**BOARD OF SUPERVISORS
PUBLIC HEARING
STAFF REPORT**

SUBJECT: ZRTD-2019-004, SPEX-2019-0037, SPEX-2019-0038 &
SPEX-2019-0039, Bles Park

Figure 2: Conceptual Design Plan / Redline Changes

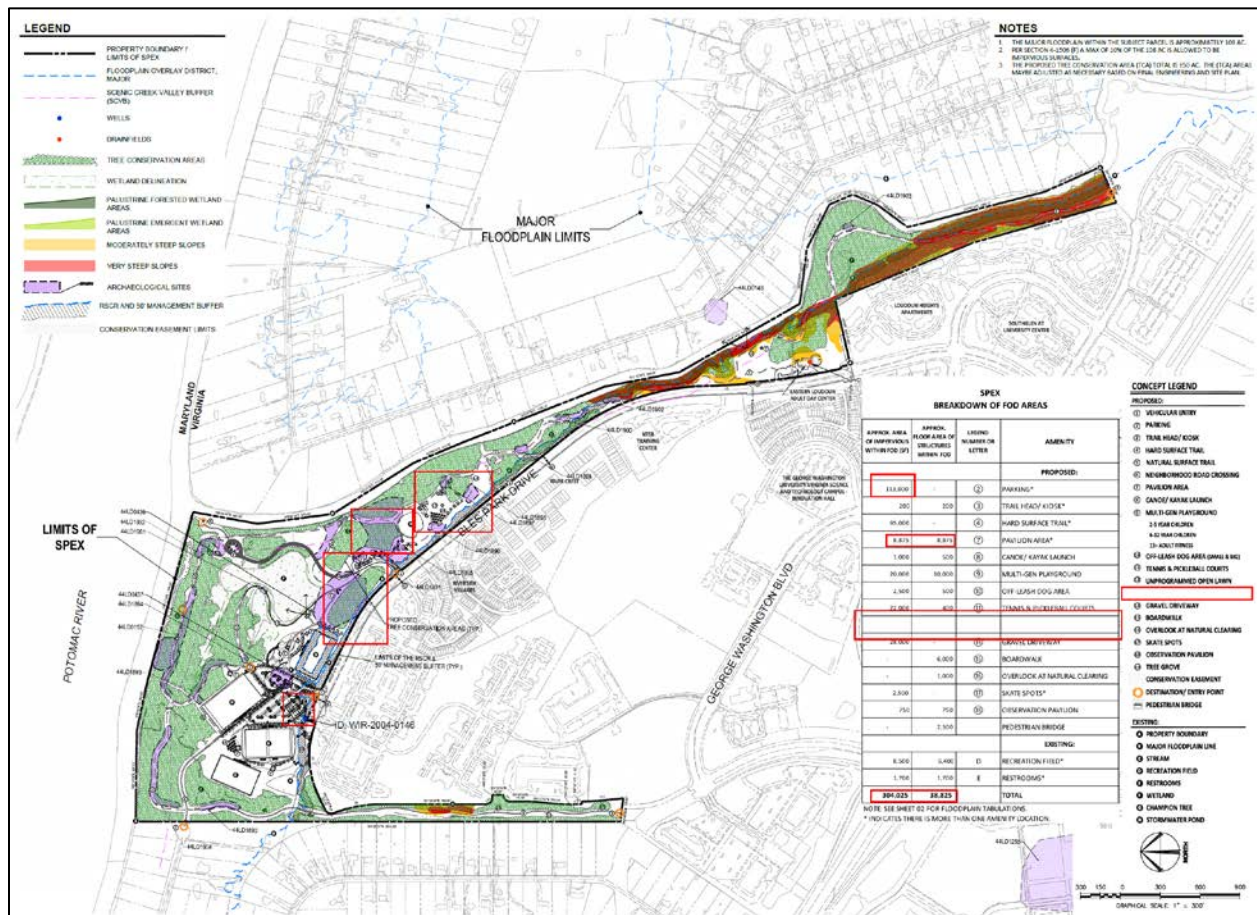
- 1) Decreased total impervious surface area by 12 percent (12%).
- 2) Decreased incidental structures by 19 percent (19%).
- 3) Decreased proposed parking areas by ten percent (10%).
- 4) Decreased a proposed open lawn area by 57 percent (57%).
- 5) Increased the proposed Tree Conservation Area by one acre.
- 6) Removed a proposed maintenance facility.
- 7) Removed five proposed pavilions.
- 8) Relocated proposed multi-purpose courts closer to existing active recreational uses and parking areas.

Figure 3: Parking Lot Reduction / Multi-Purpose Court Relocation

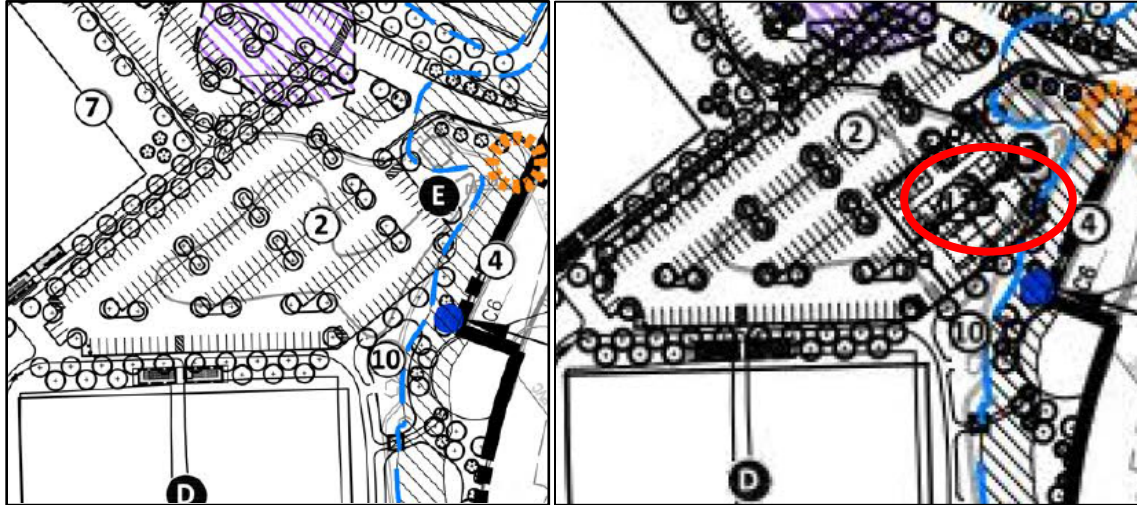
Figure 3: From the first submission (left), the number of proposed parking spaces has been reduced by ten percent (10%) (±30 spaces). Also, the multi-purpose court has been moved to the parking area (circled in red).

Figure 4: Maintenance Facility (Removed)

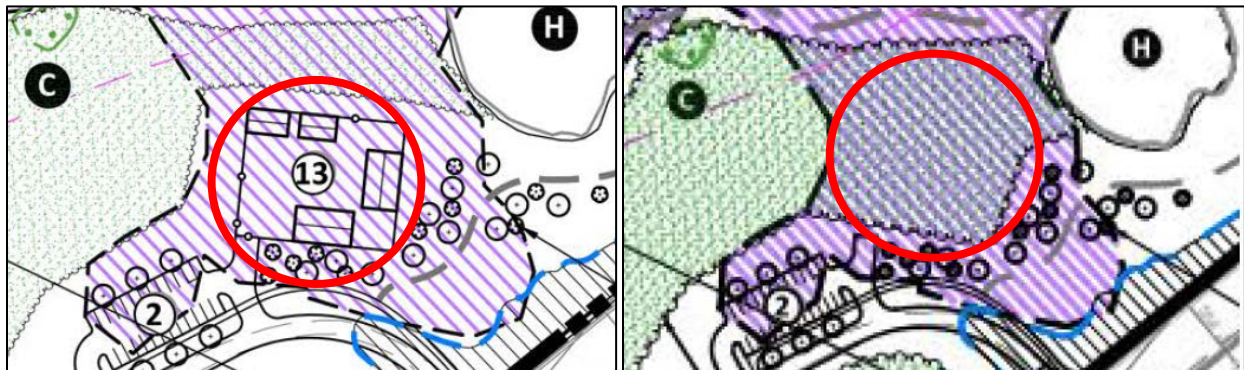
Figure 4: The proposed maintenance facility (red circle) was removed completely in this submission, which reduced the amount of impervious area by 18,000 SF and the incidental structure area by 6,000 SF.

Figure 5: Unprogrammed Lawn Area (Reduced)

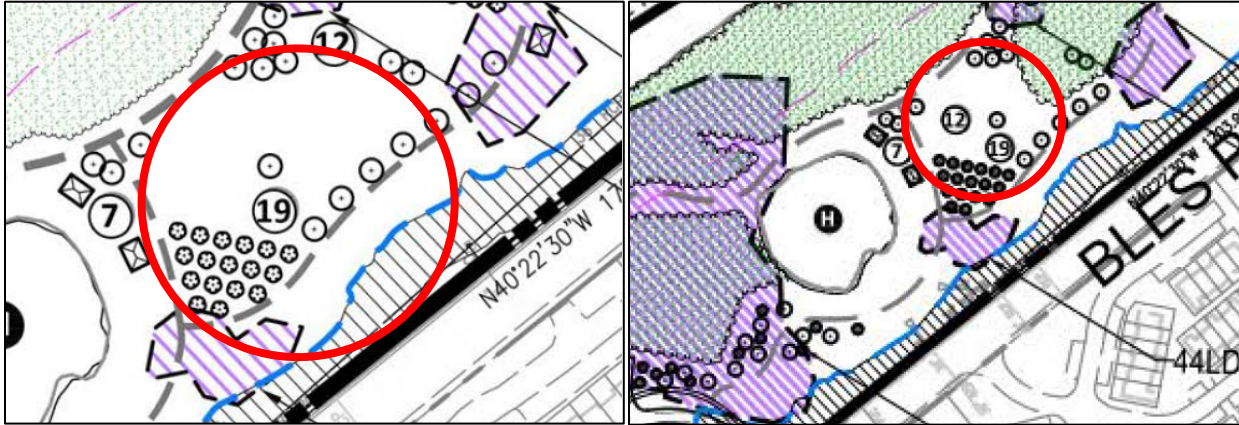
Figure 5: The proposed unprogrammed lawn area (red circle) was reduced by 57% in this submission.

Figure 6: Multi-Use Court (Relocated)

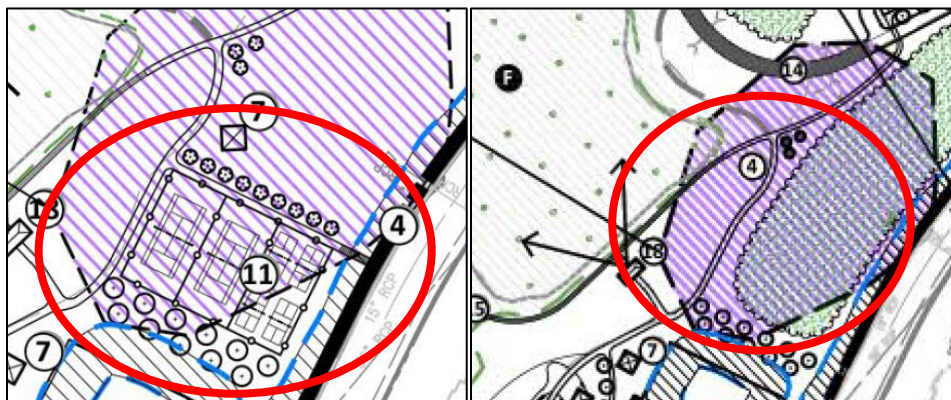
Figure 6: The proposed multi-use courts (red circle) were moved from the original proposal (left) to the parking lot shown in Figure 3.

Figure 10: Recommended Locations for Additional Phase I Archeological Survey

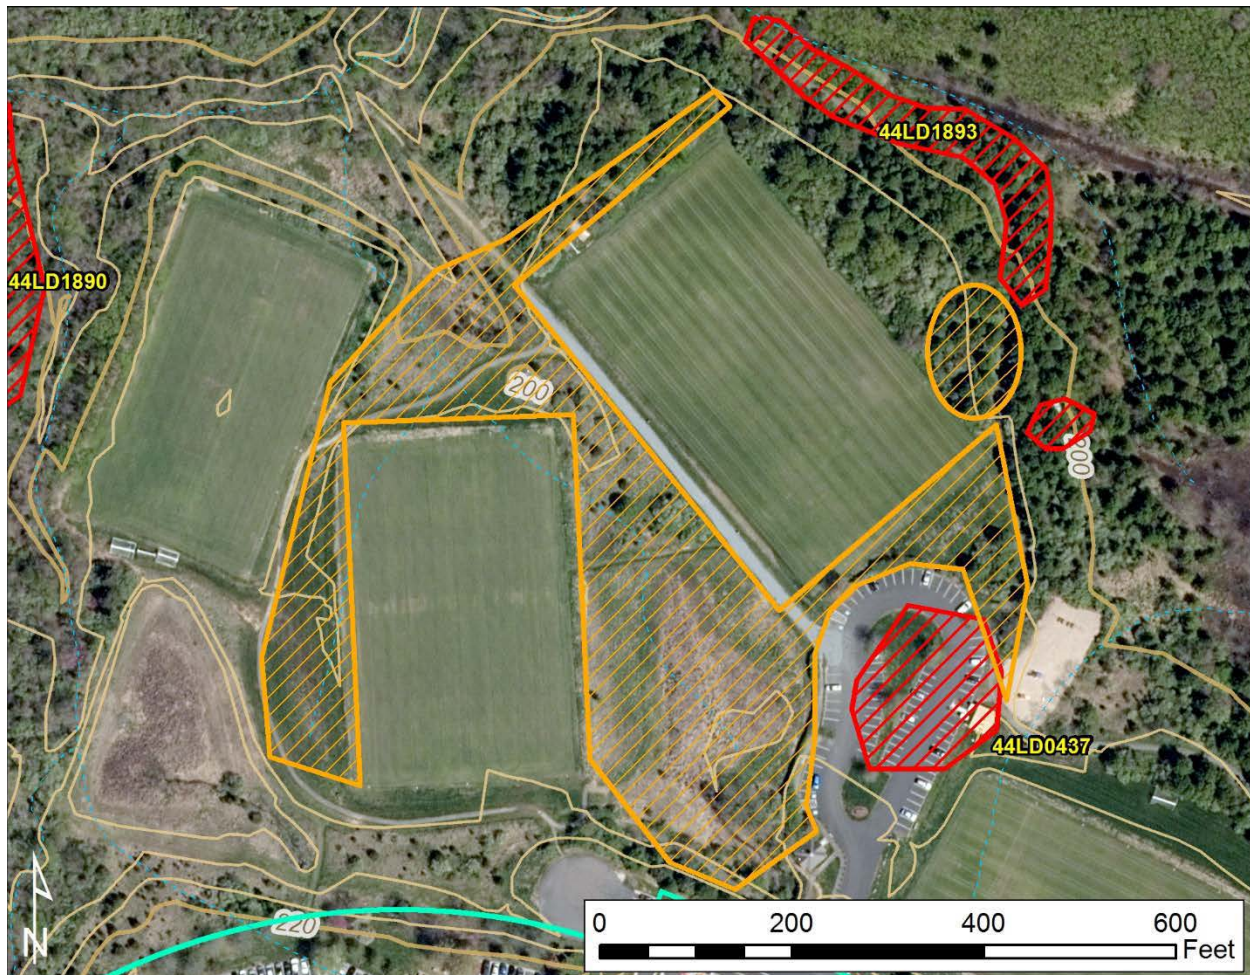
Historic Resources. A Phase 1 Archeological Survey has been provided by the applicant, and the County Archaeologist has identified several areas of potential historical and archeological significance. Initially, staff recommended that the applicant complete a more in-depth Phase 2 Archeological Survey for the impacted sites. However, the applicant was not sure of the exact final location for the proposed amenities or if all of the requested amenities will receive funding in the future. Therefore, staff has drafted a condition requiring the applicant to submit a Phase 2 Archeological Survey and potentially a Phase 3 Archeological Survey when/if amenities would be impacted at the site plan stage.

Figure 10: Map of Bles Park showing area (orange hatching) where additional Phase I archaeological survey is recommended. The red hatched areas are sites already recorded with the Virginia Department of Historic Resources.

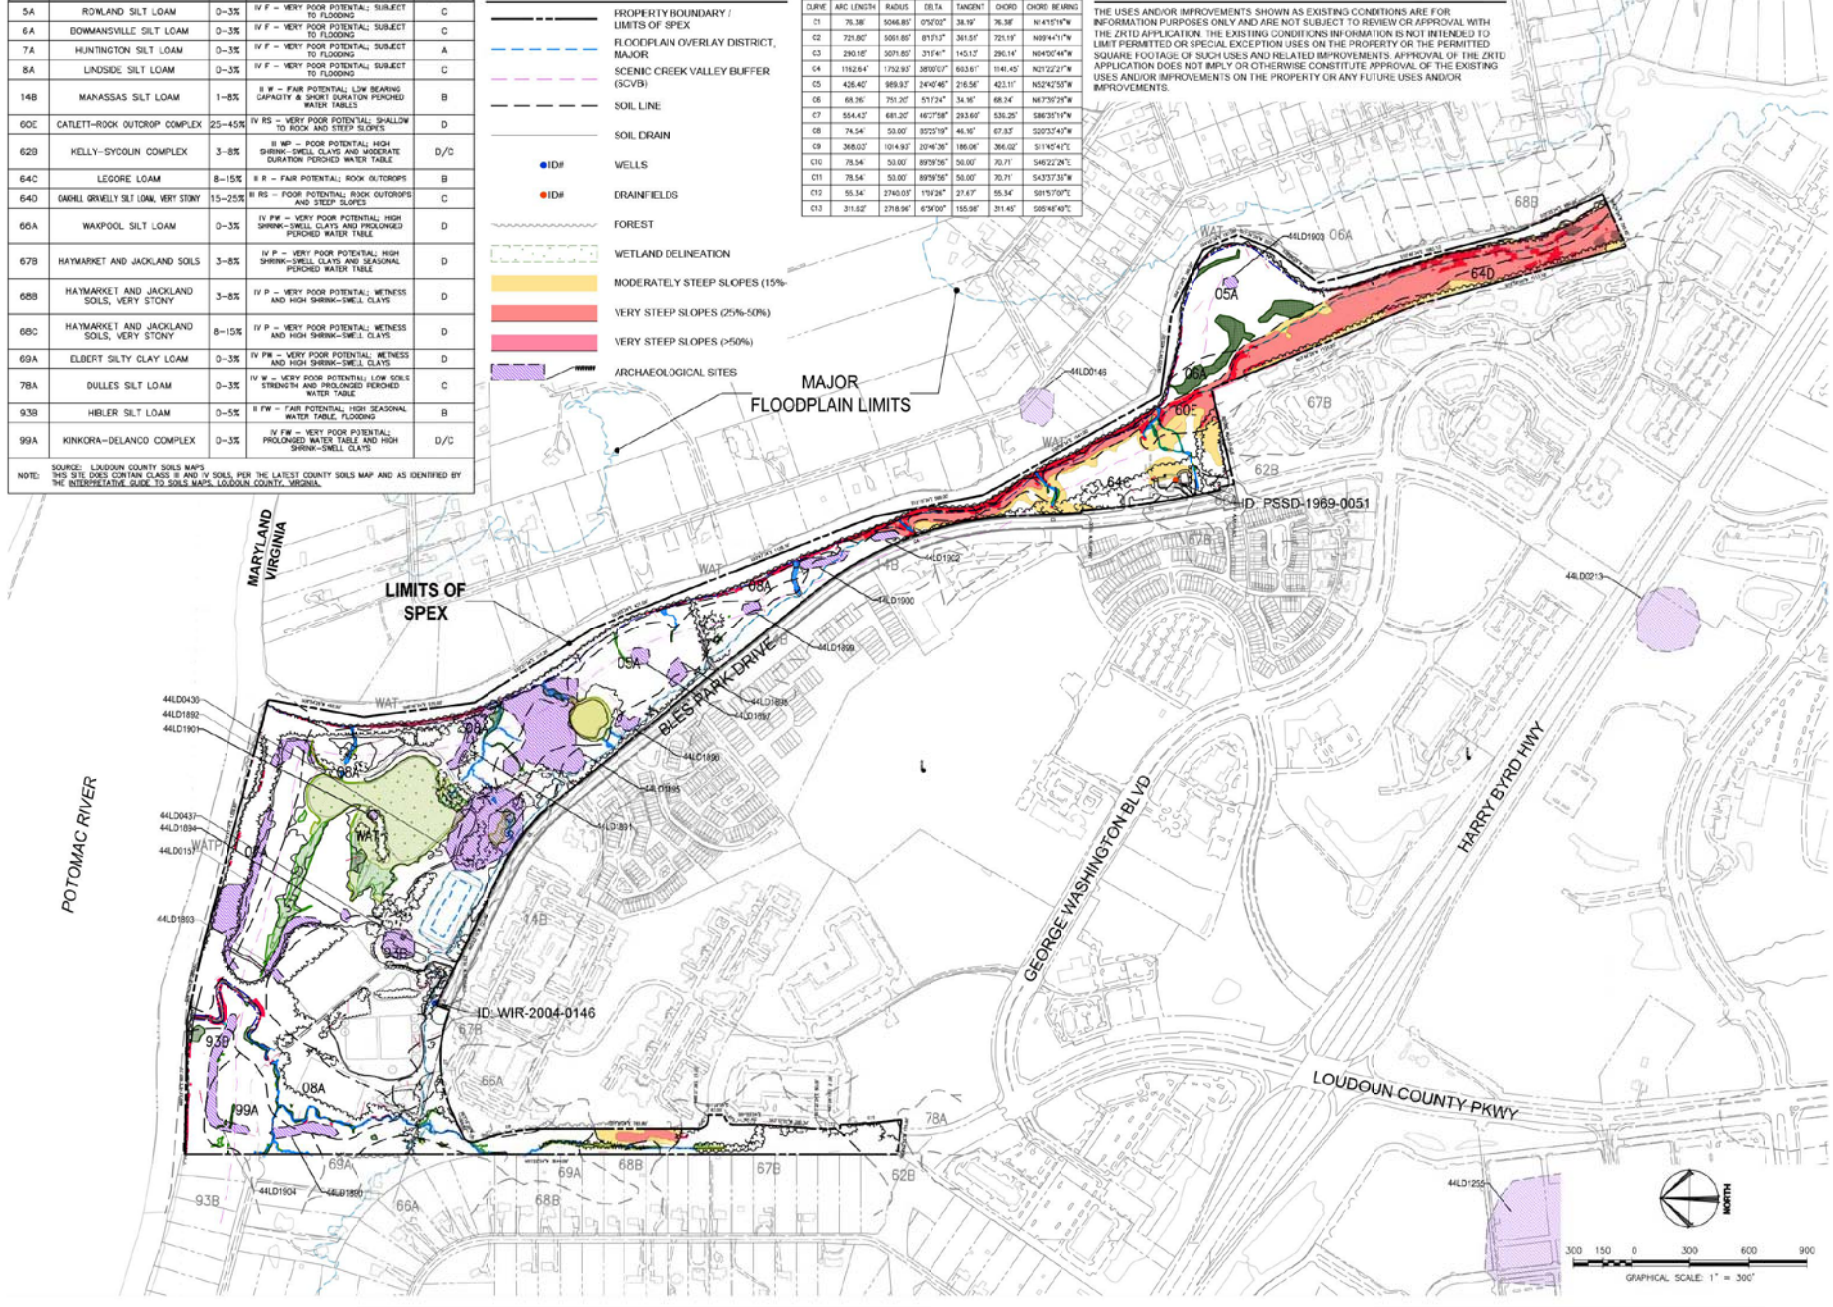
- 11) Update General Note 8 (Source of Floodplain Note) on Sheet 2 to reflect the correct Flood Insurance Rate Map (FIRM) of Loudoun County Community Panel Numbers: 51107C0255E, 51107C0265E, and 51107C0266E. (FSM 8.101.A.20)

- 12) For clarity, as minor floodplain is not present on the subject property and the Source of Floodplain Note is provided, please remove the first sentence in General Note 8 on Sheet 2. (FSM 8.101.A.20)

- 13) Staff recommends updating the first sentence in the last paragraph of the Floodplain Narrative on Sheet 2 as follows: “It is the opinion of Gordon that the proposed...”

- 14) Staff recommends updating the last two sentences in the last paragraph of the Floodplain Narrative on Sheet 2 as follows: “If there is no change to the base floodplain elevation, then a CLMOR submission to FEMA is not anticipated. A LOMR submission to FEMA will be processed with the development as-built condition should the floodplain boundary or base flood elevation change.”

Comment 10: Sheet 2. Revise General Note 1 to replace “All parcels” with “The parcel...”

Comment 12: Sheet 2. Revise General Note 24 to indicate which sheets are identified as being subject to substantial conformance as the SPEX Plat, as the way the note is currently written the substantial conformance would be required to all 11 sheets of the plan set.

Response: General Note #1 on Sheet #2 has been revised.

Response: General Note #24 on Sheet #2 has been revised to reference SPEX Plat (Sheet 6-8) as being subject to substantial conformance.

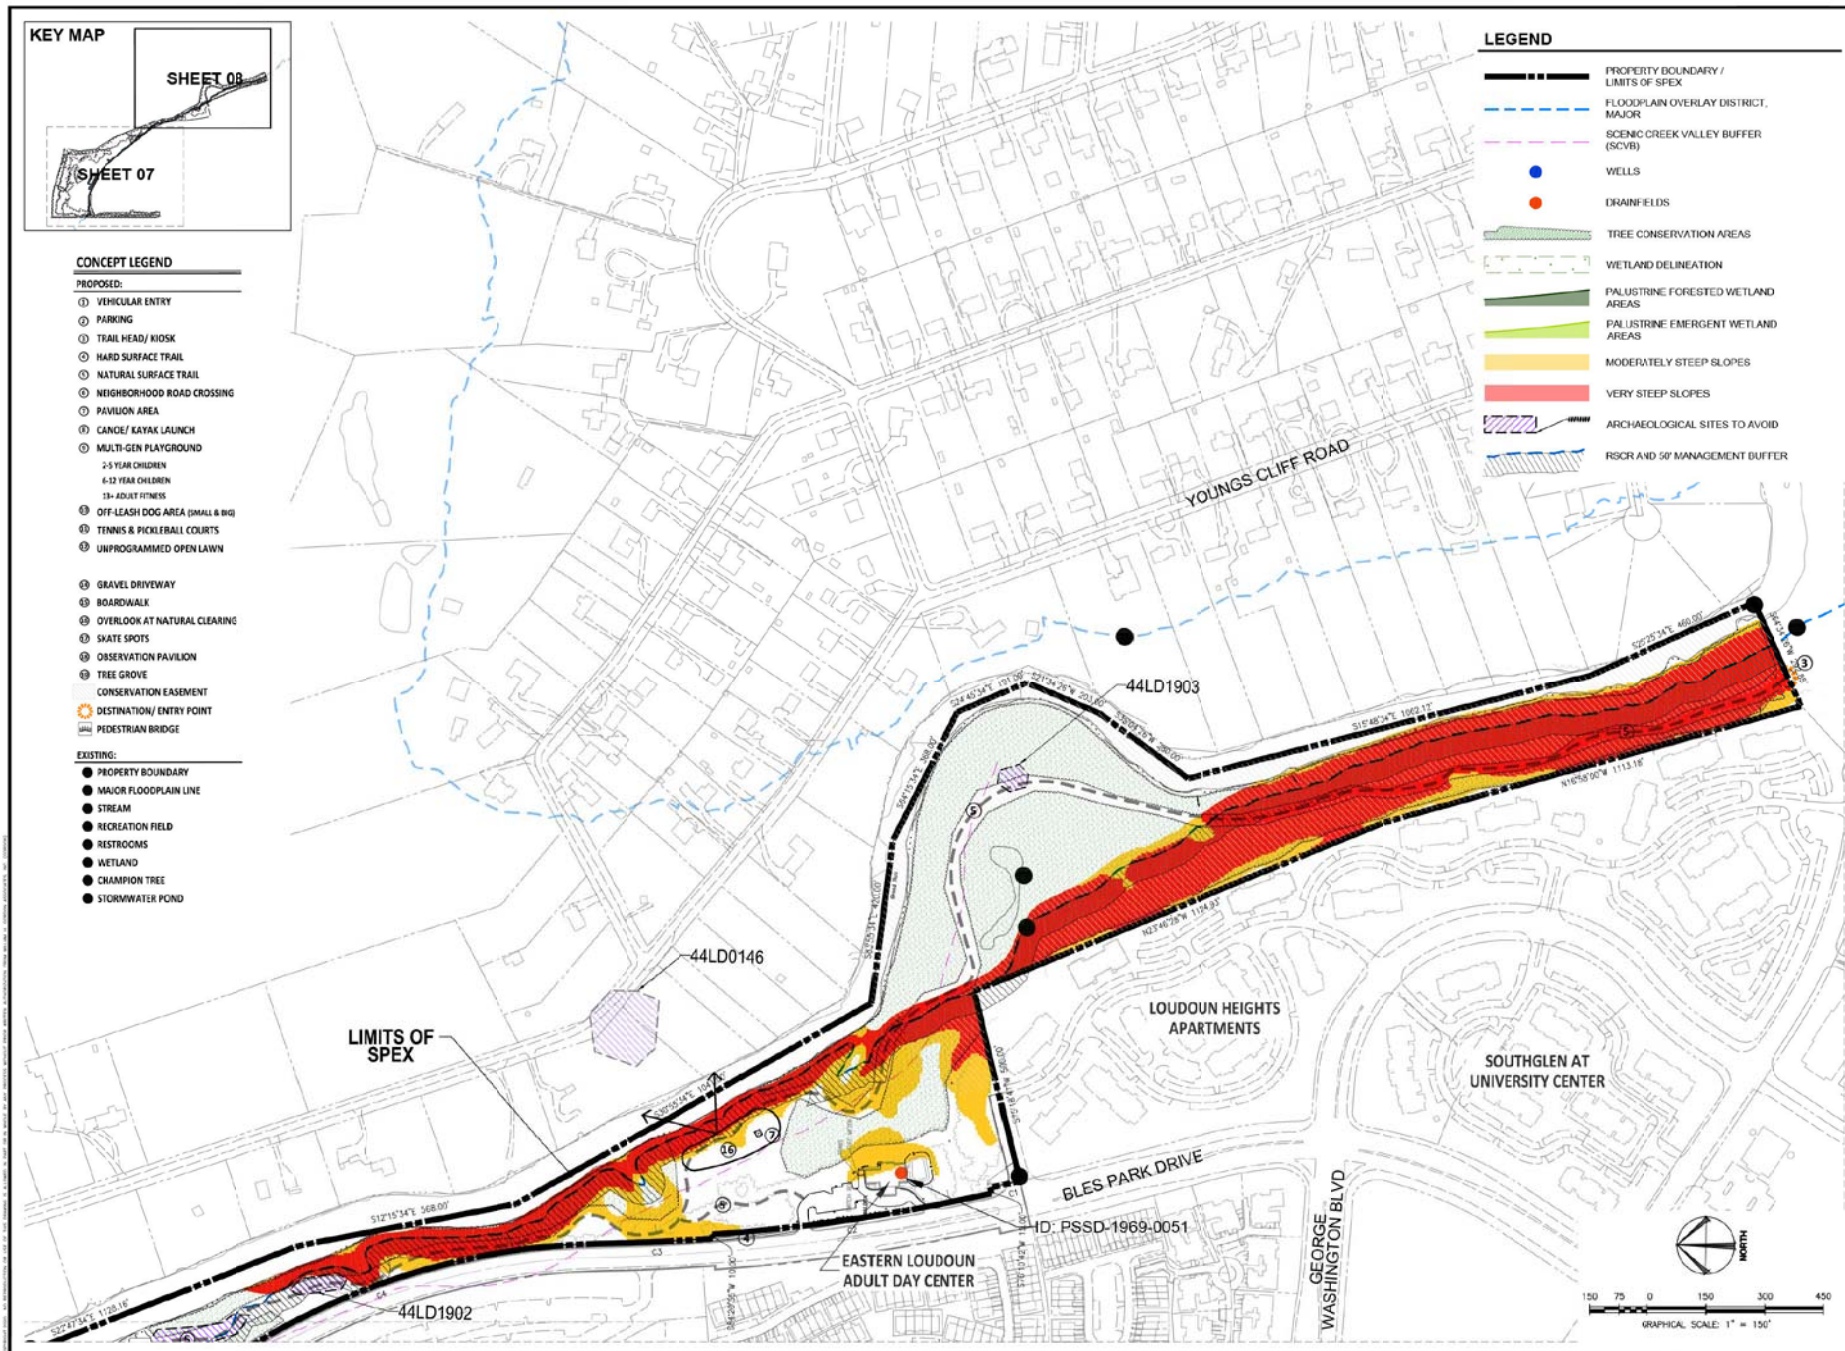
- 9) Staff request information regarding the proposed improvements identified in the legend/table on Sheet 6 to confirm that the square footage areas are listed under the appropriate column (impervious surface vs. floor area of incidental structures). Specifically, please provide details for the multi-gen playground, off-leash dog area, skate spots, boardwalks, and pedestrian bridges (i.e. type of surface, materials being used, brief description of the improvement).

- 10) Please review and verify that the floor area for the pedestrian bridges in the legend/table on Sheet 6 is correct and accounts for the site terrain in the area of the proposed crossings.

- 16) Provide the total floodplain acreage/square footage on the property to demonstrate the that the total area of imperviousness provided in the table on Sheet 6 does not exceed the 10 percent maximum specified in R93ZO 4-1506(F).

Comment 14: Sheet 6. Revise the sheet label to identify the sheet as the SPEX Plat.

Comment 15: Sheet 6. Remove the contour lines from the SPEX Plat.

Comment 16: Sheet 6. Revise note 2 to replace "flood" with "floodplain".

Response: Sheet 6 has revised as the SPEX Plat as suggested.

Response: The contour lines have been removed from Sheet 6 as requested.

Response: The Notes on Sheet 6 has been revised and Note 2 is now Note #1 has been revised as suggested.
